**ALLEGHENY COUNTY SANITARY AUTHORITY**

**CONTRACT NO. 1735 G, E, H, P**

**ALCOSAN PARKING GARAGE**

**ADDENDUM NO. 2**

210-P-01

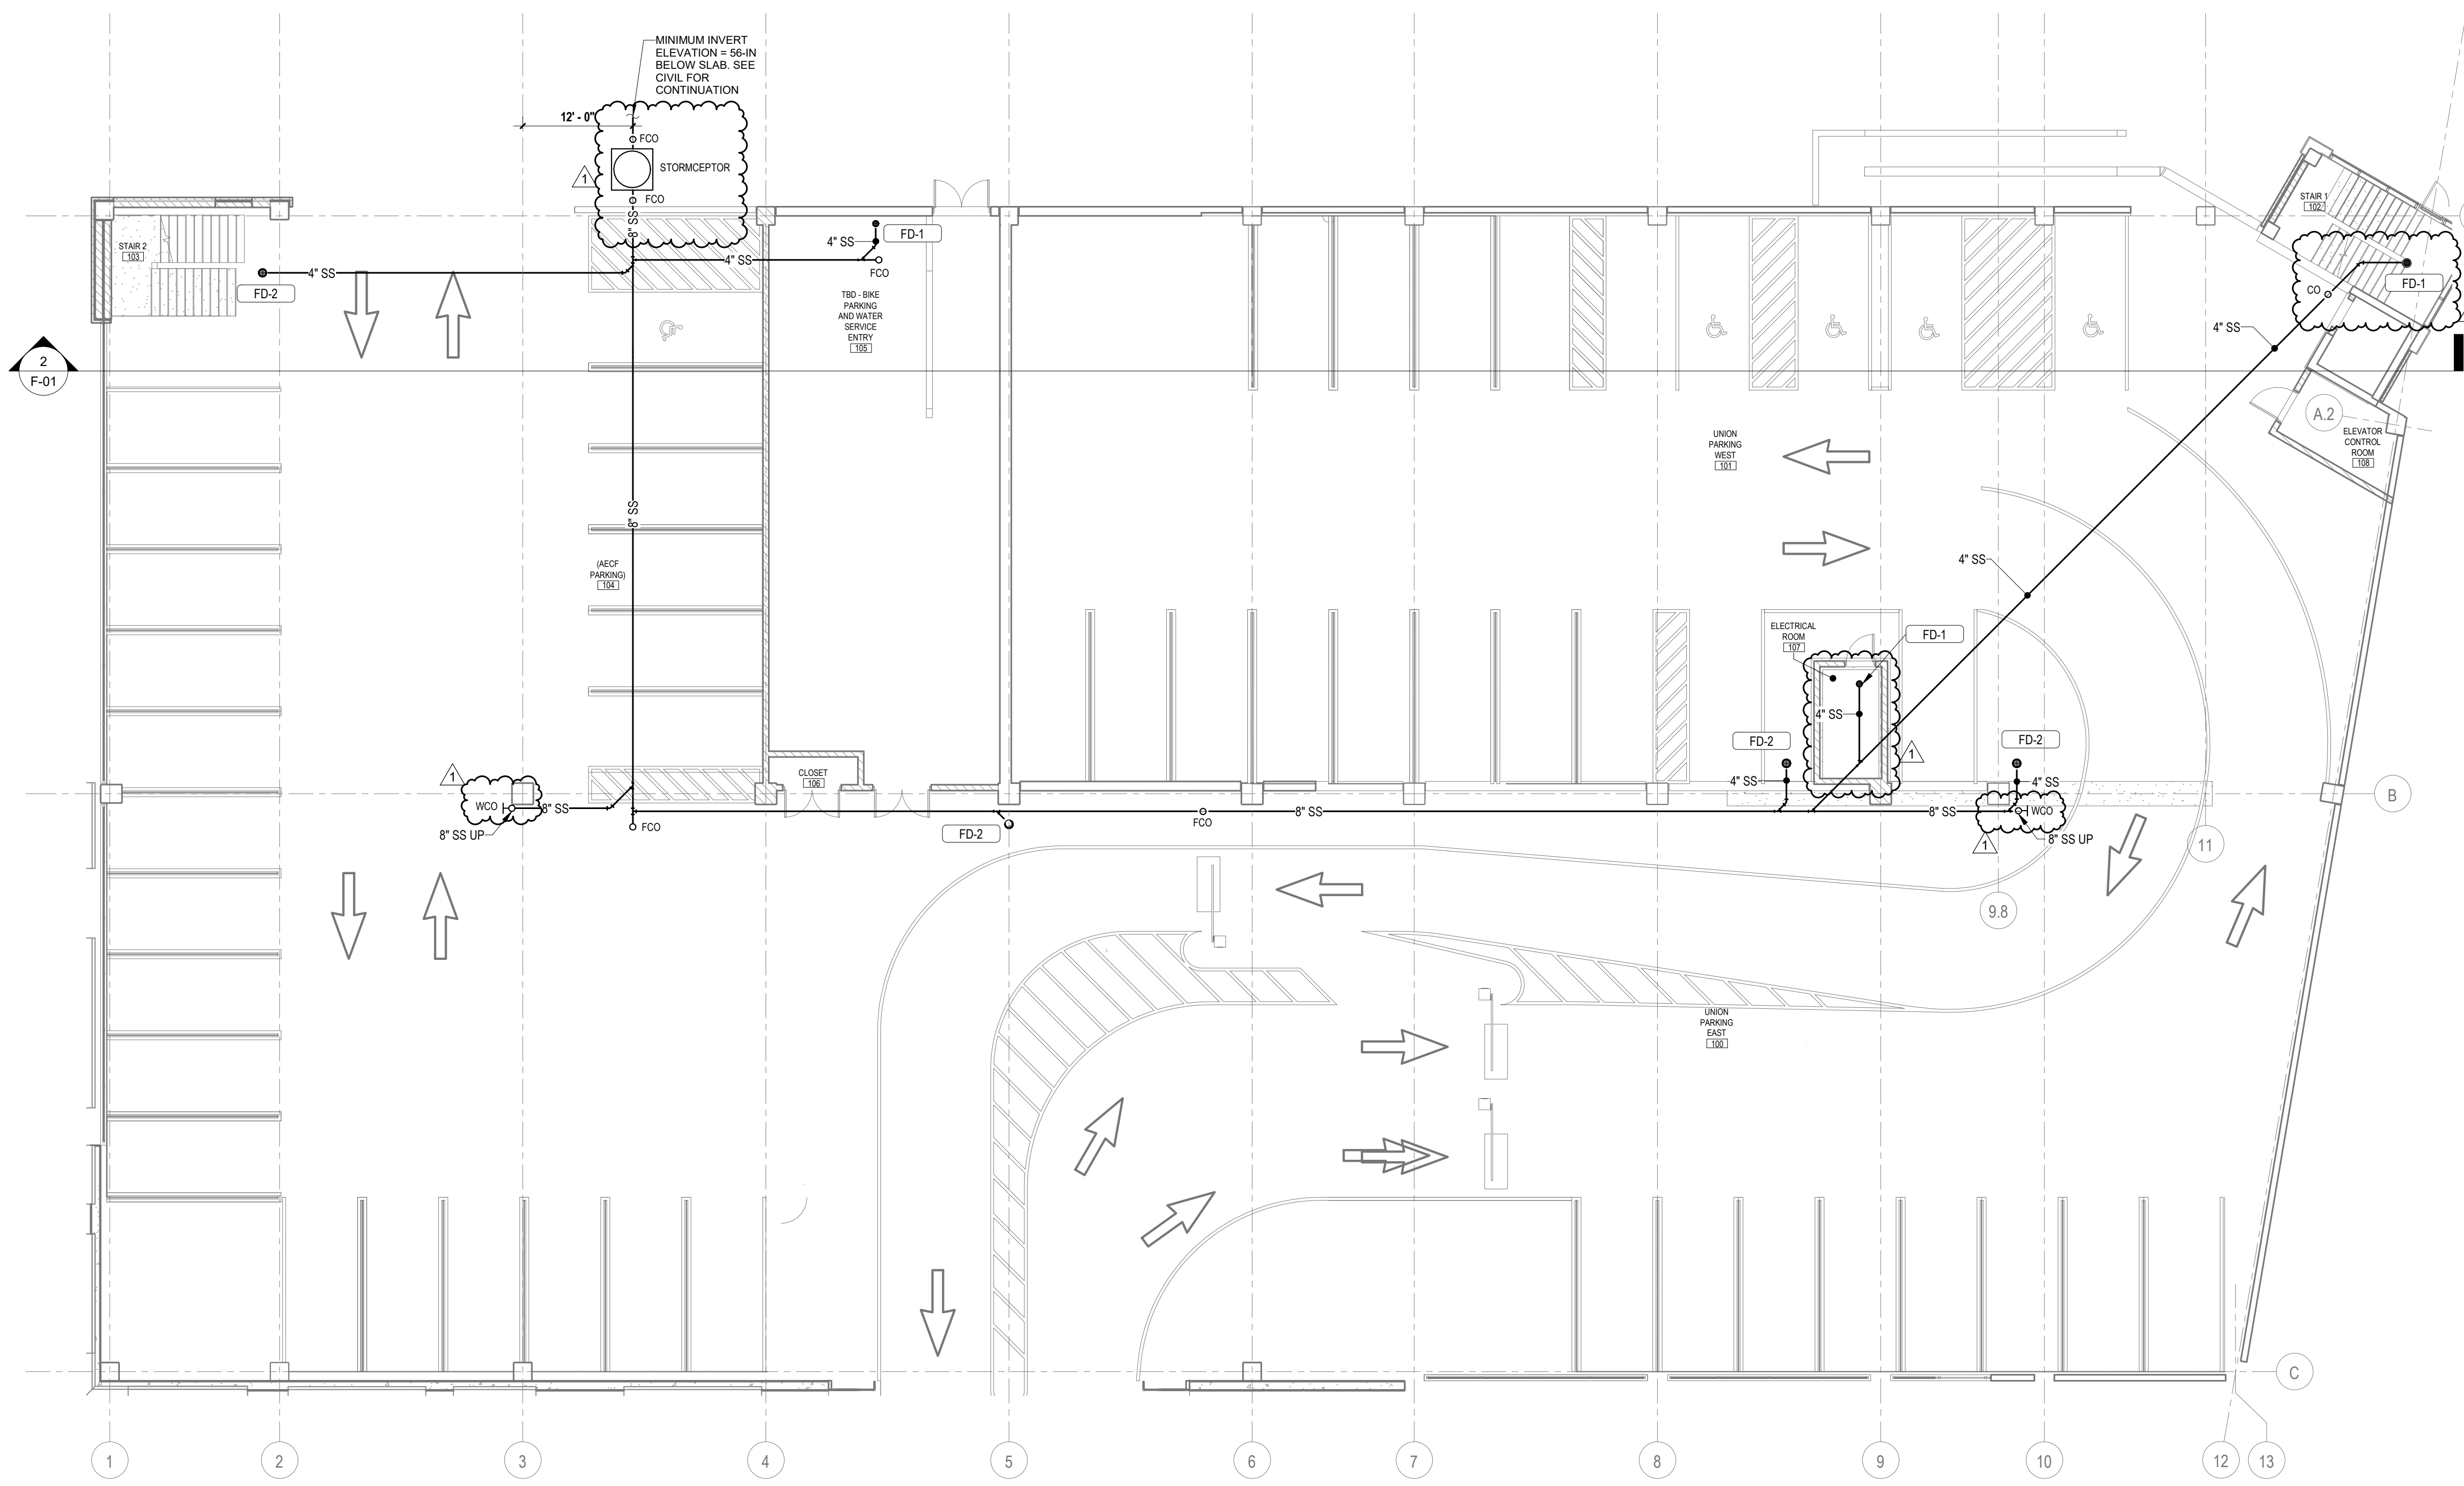
72. Drawing 210-P-01
- a. DELETE this drawing and REPLACE with the attached drawing 210-P-01.
  - b. Updated sanitary riser diagram with appropriate cleanouts, stormceptor, and updated pipe sizes.

- c. Updated storm sewer references in abbreviations, titles, and general notes.
  - d. Updated sheet title to reflect storm.
73. Drawing 210-P-10
- a. DELETE this drawing and REPLACE with the attached drawing 210-P-10.
